TITLE:-4LEAF BOTH SIDE SLIDING
CRM DOOR-10

CLIENT - LESTECH
LOCATION - POSCO MANGAON
PRODUCT - SLIDING DOOR
DWG NO:-NIHVA/22-23/CLT/0017 | REV- 0
SCALE: NTS | SCALE:-- 1:1 | SHEET: 01 OF 01

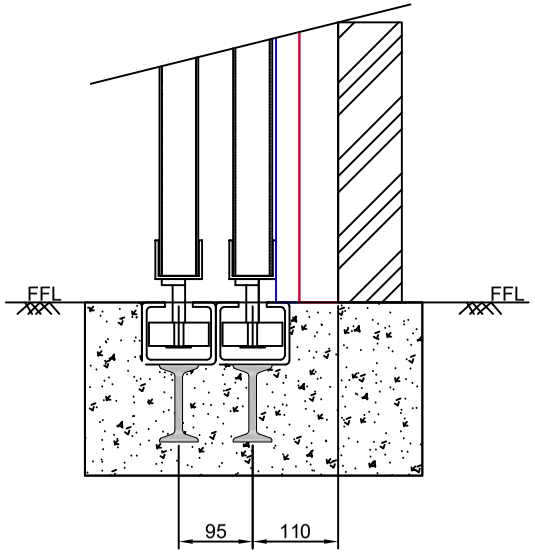
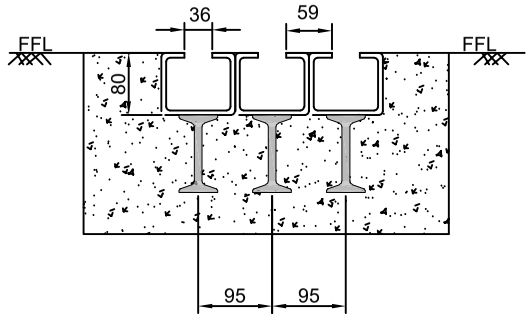
Client scope
*Roof need to be shift at top Approx 300mm *Drainage area need to be remove frome left side appox.200mm *Gutter area need to be remove *Civil foundation need to be done for tracks
